ADDENDUM NO. 1

**New Outdoor Pavilion
Missouri Veterans Home
St. James, MO
PROJECT No.: U2610-01**

Bidders are hereby informed that the Construction Plans and/or Specifications are modified as follows:

SHEET NUMBER:
C-200

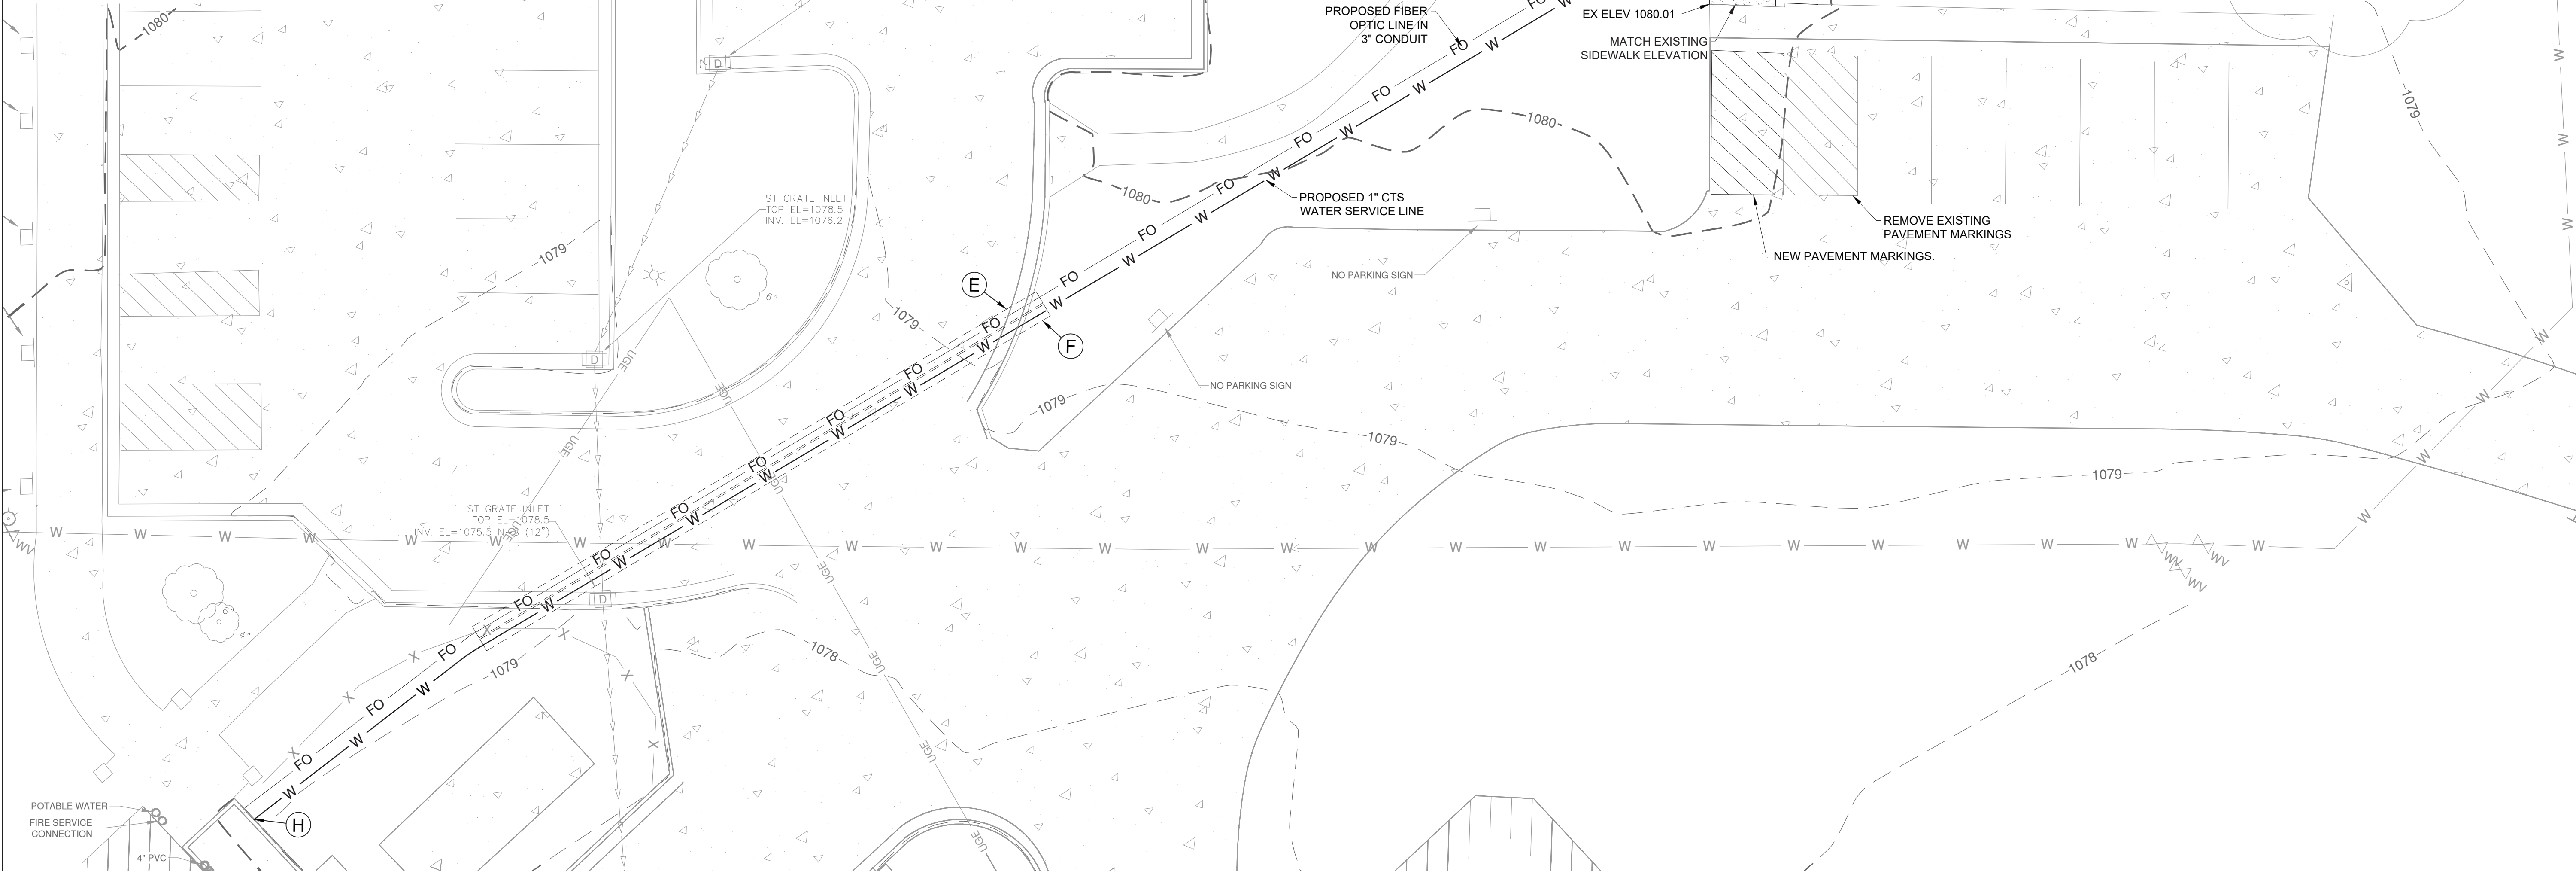
1. SHEET C-101
 - a. ADD General Note #10 as follows:
 10. The entire existing pavilion building/structure is to be demolished as part of the project scope. See notes for protection of and reuse of existing adjacent site utilities.
2. SHEET C-200
 - a. REVISE the communication, electric, and water line alignment near to the restroom building to conform with the plumbing and electrical sheets. (See attached).
3. SHEET A-150
 - a. REMOVE AND REPLACE Ceiling Type C1 with the following:

SITE POWER PLAN 2 E-100

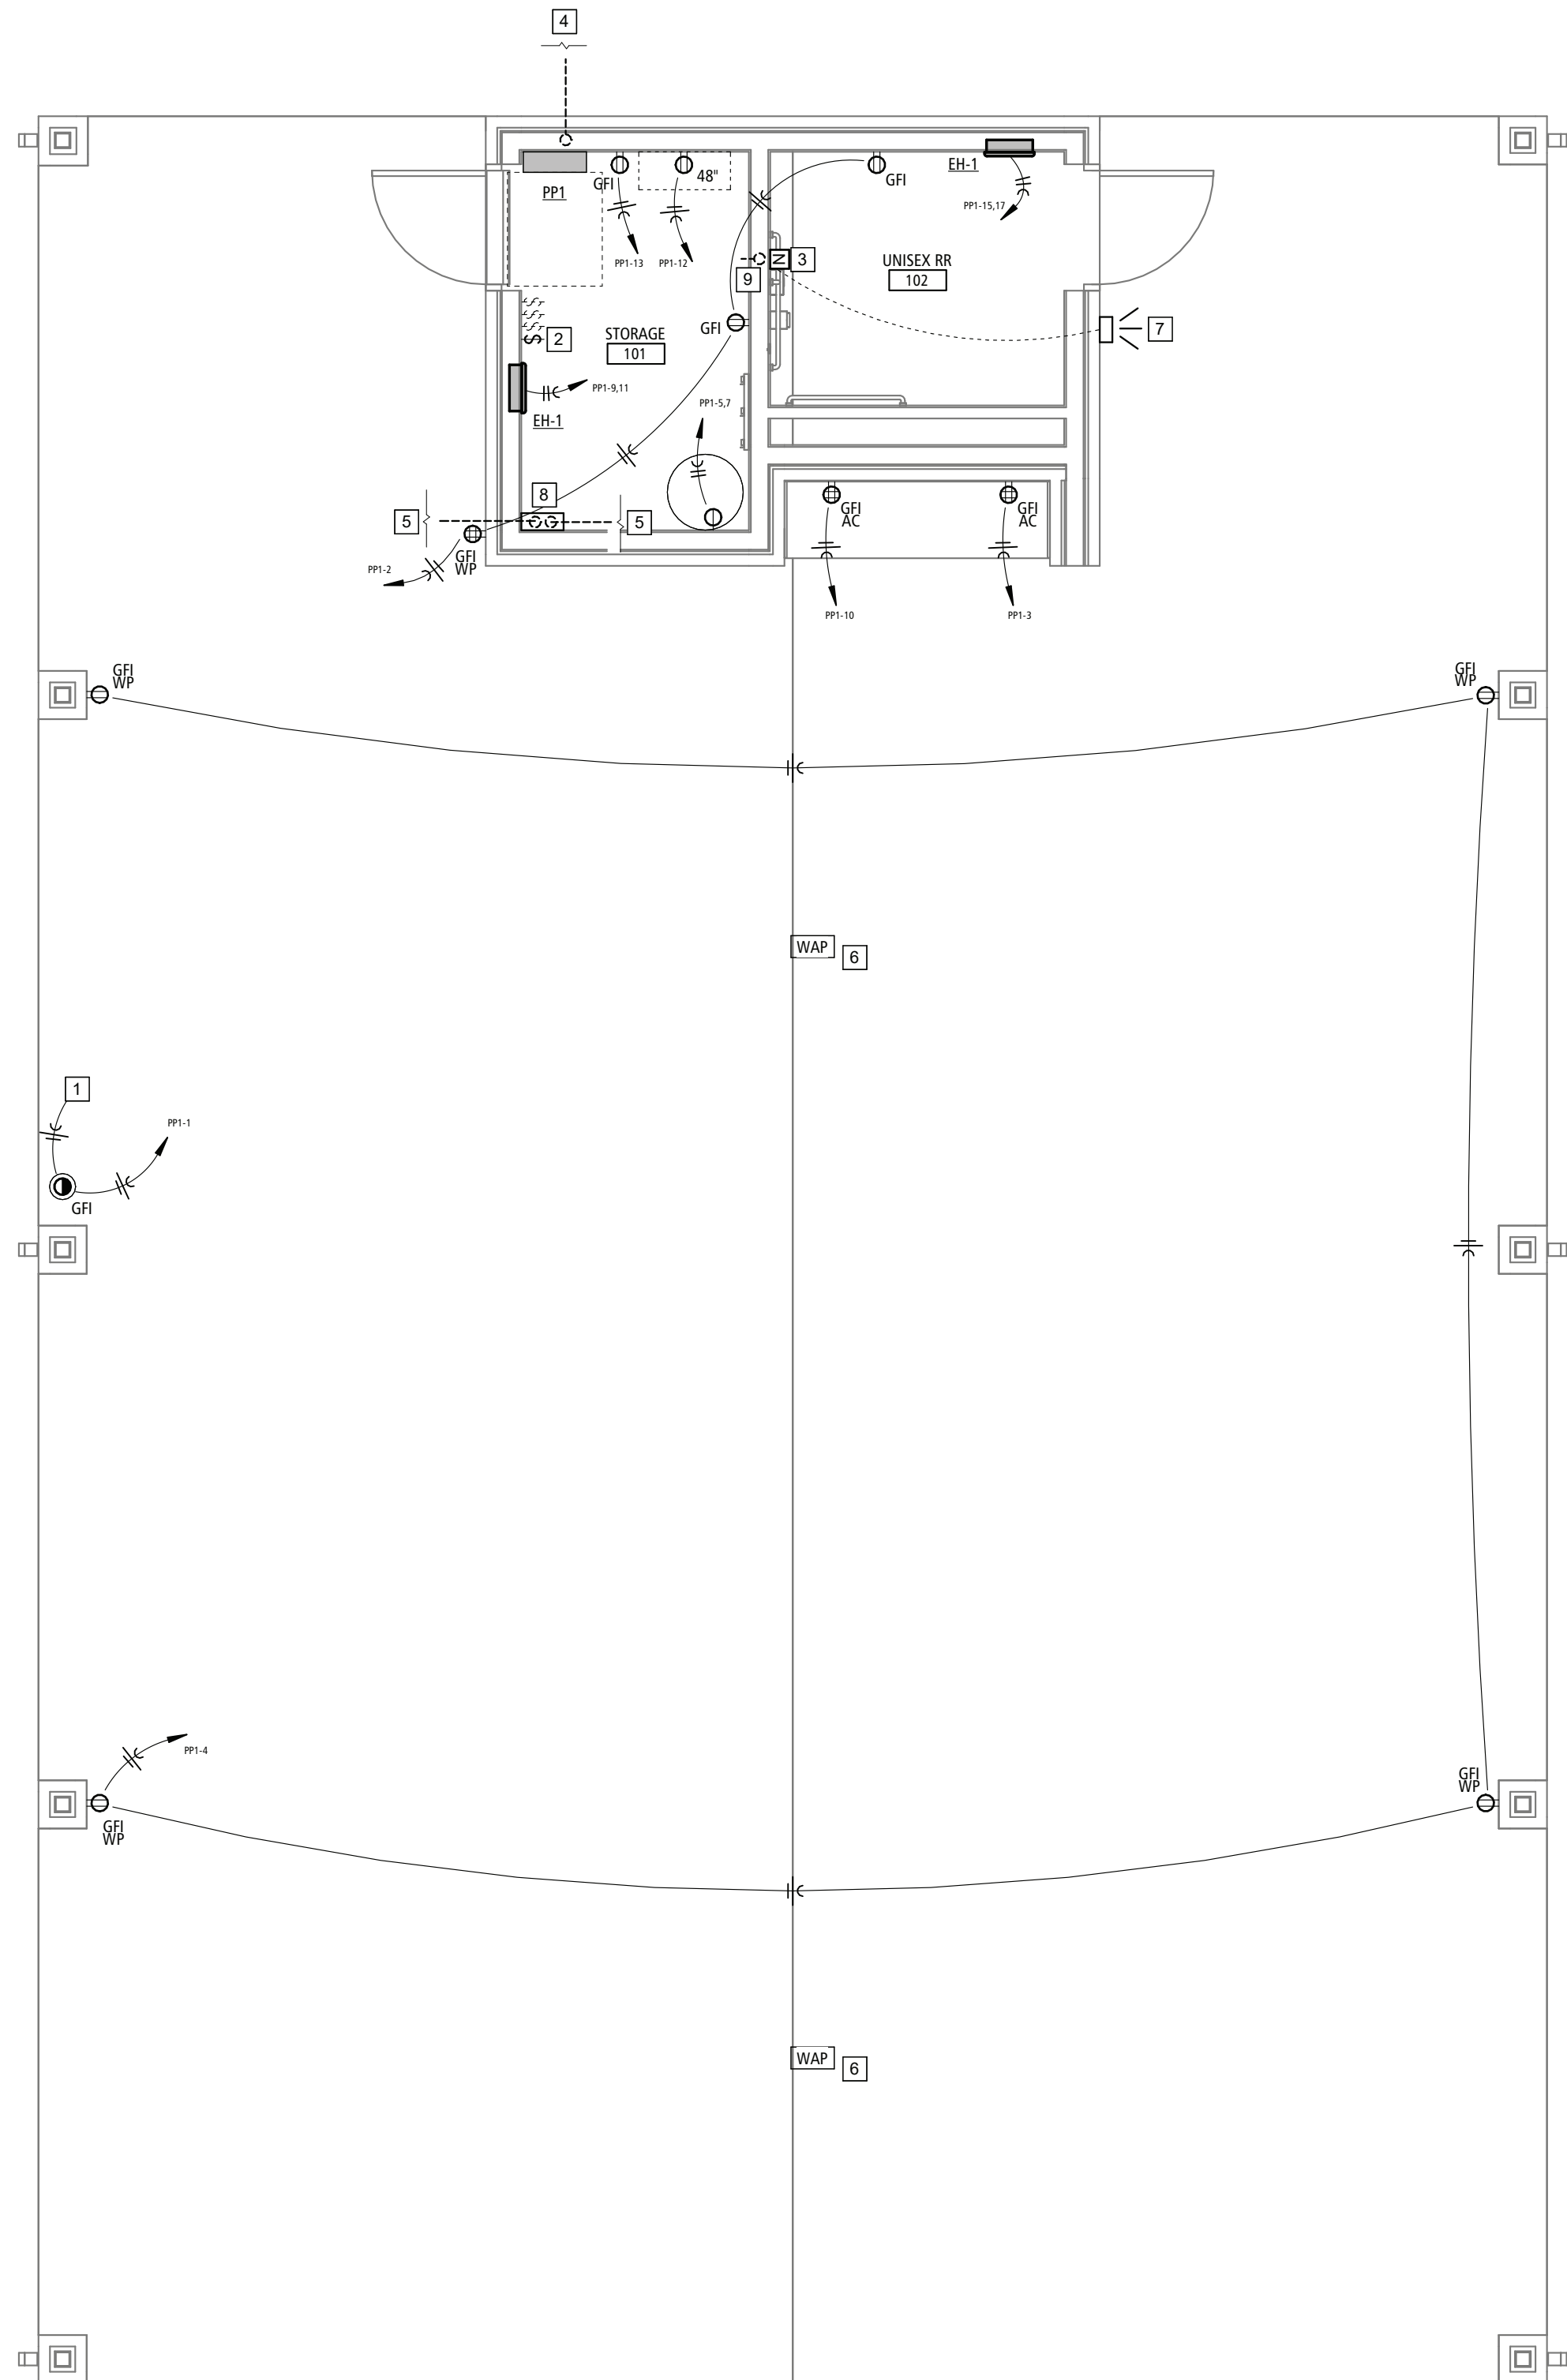
6. SHEET E-100

a. REMOVE AND REPLACE note on Detail 2/Site Power Plan conduit pathway as follows: (See attached)

(1) 3" DATA CONDUIT TO EXISTING BUILDING. FOLLOW PATH OF WATER LINE. REFER TO CIVIL C-200 FOR PATHWAY.
